**2019 CMOM Package 3 (Urgent) Project  
Solicitation Number: CO-00377-FG  
Job No.: 19-4542**

**ADDENDUM #1  
October 30, 2020**

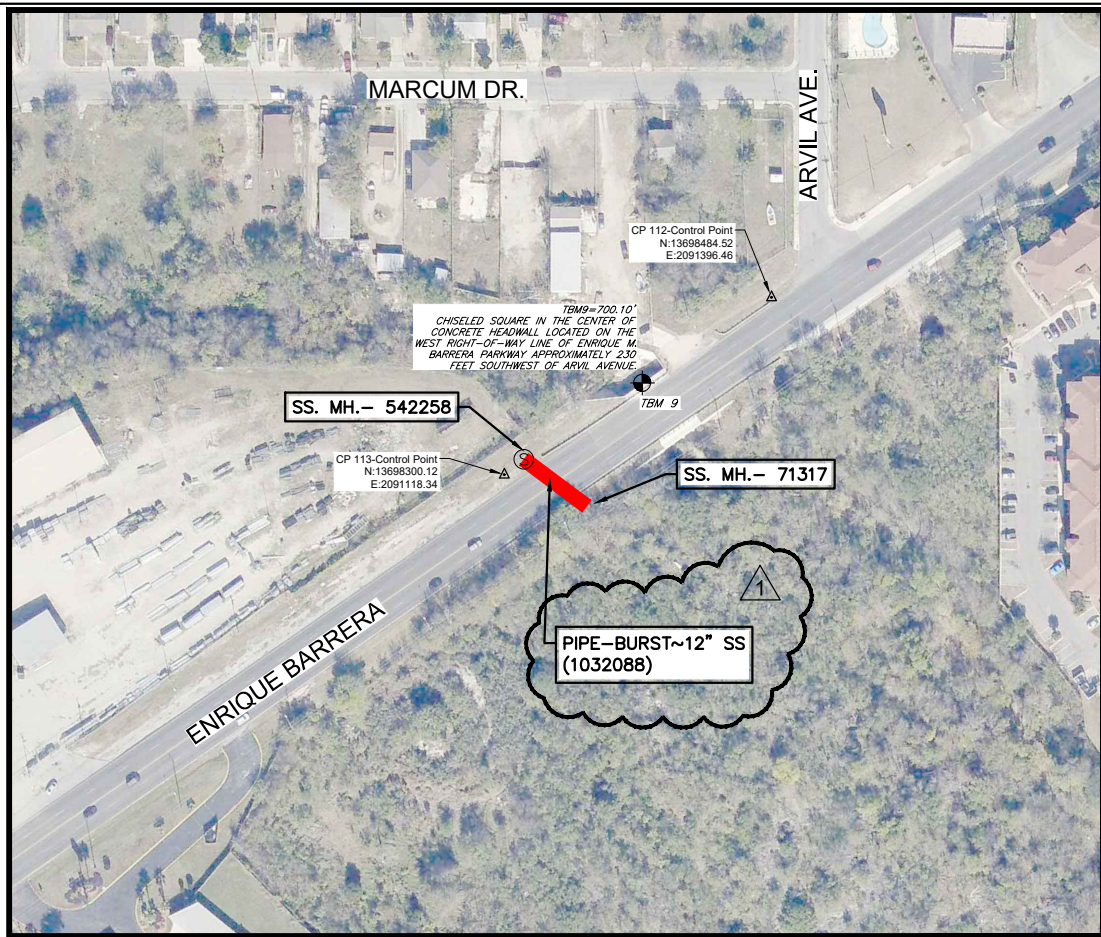
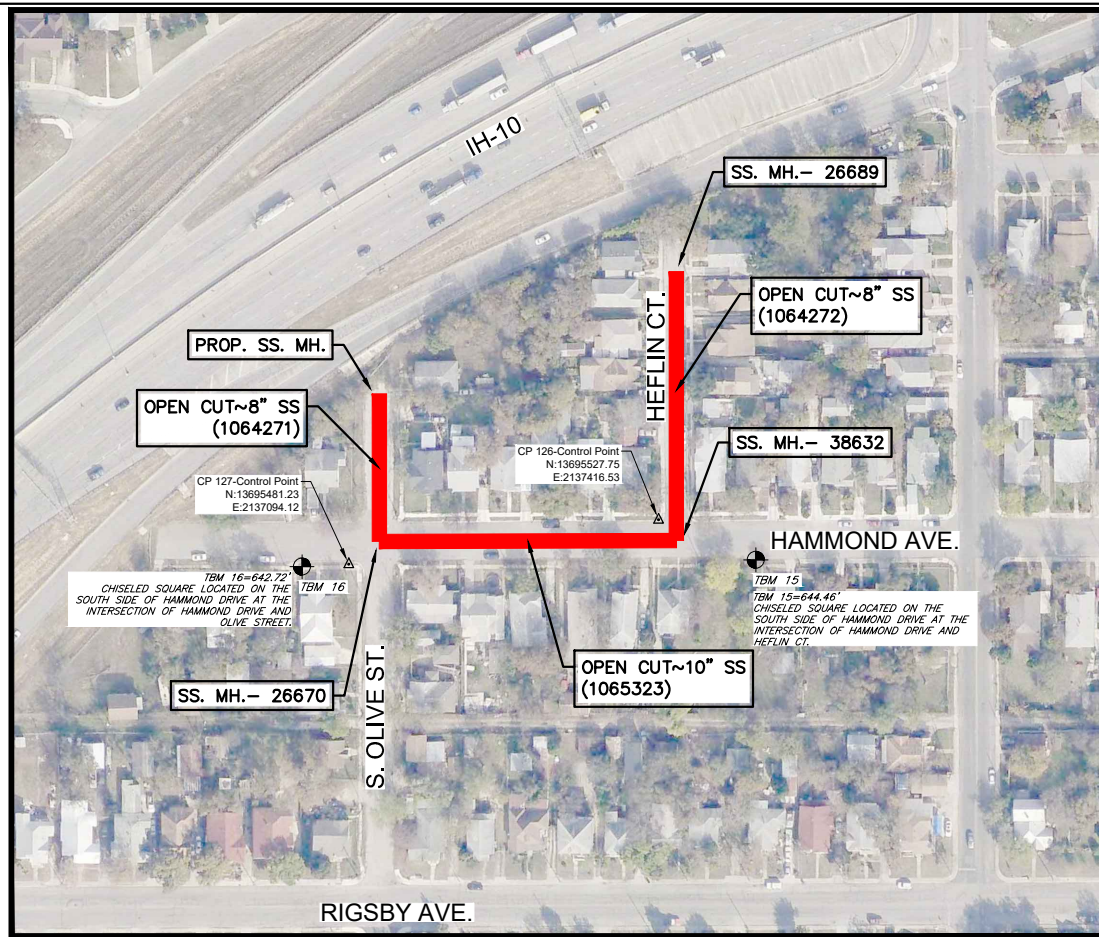
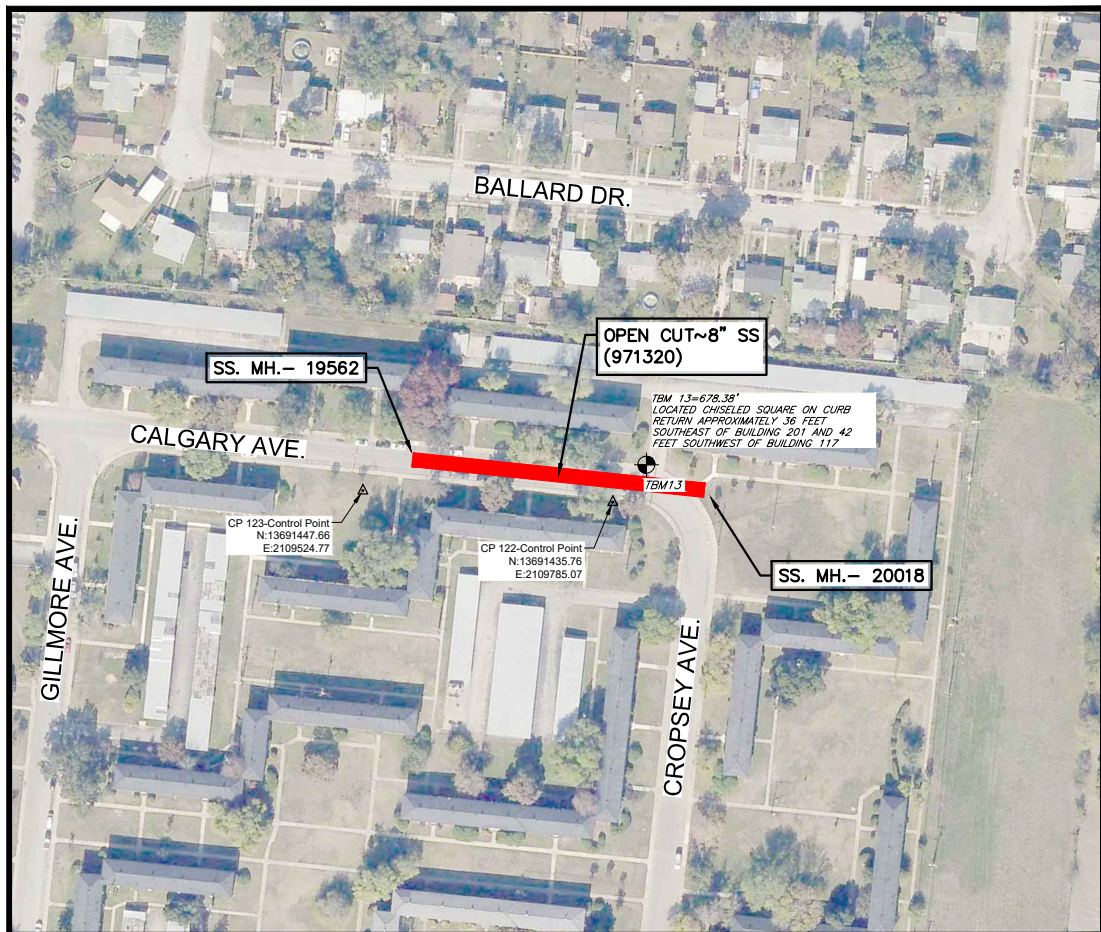
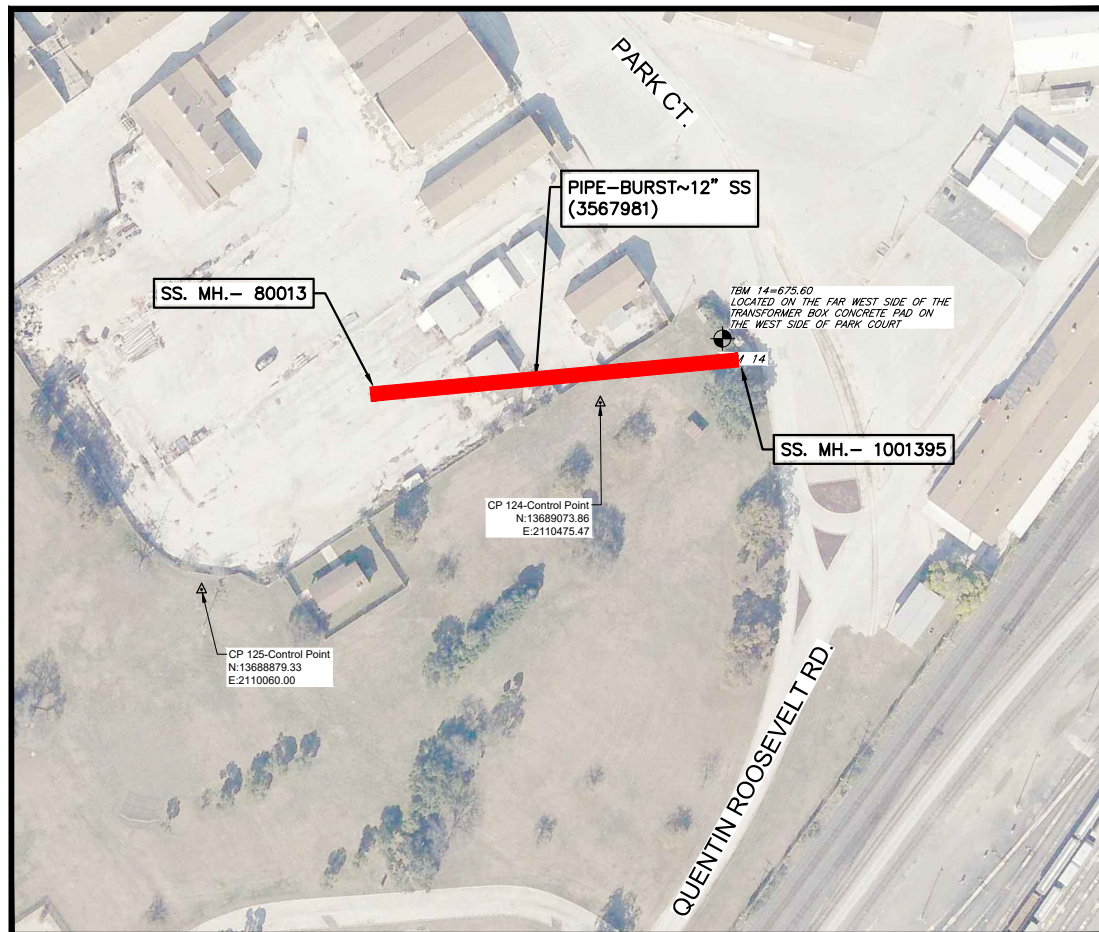
- 1. Plan Sheet G-3, 3 of 35:** Remove and replace Plan Sheet G-3, 3 of 35, with the revised Plan Sheet G-3, 3 of 35, attached to this Addendum. Plan Sheet G-3, 3 of 35, has been revised to change the item description for Item No. 900 from “PIPE BURSTING 10” SANITARY SEWER PIPE, (20’-25’ DEPTH)” to “PIPE BURSTING 12” SANITARY SEWER PIPE, (20’-25’ DEPTH)”.
- 2. Plan Sheet G-10, 10 of 35:** Remove and replace Plan Sheet G-10, 10 of 35, with the revised Plan Sheet G-10, 10 of 35, attached to this Addendum. Plan Sheet G-10, 10 of 35, has been revised to change the proposed pipe-burst line size from 10” to 12”.
- 3. Plan Sheet I-1, 23 of 35:** Remove and replace Plan Sheet I-1, 23 of 35, with the revised Plan Sheet I-1, 23 of 35, attached to this Addendum. Plan Sheet I-1, 23 of 35, has been revised to change the proposed pipe-burst line size from 10” to 12”.
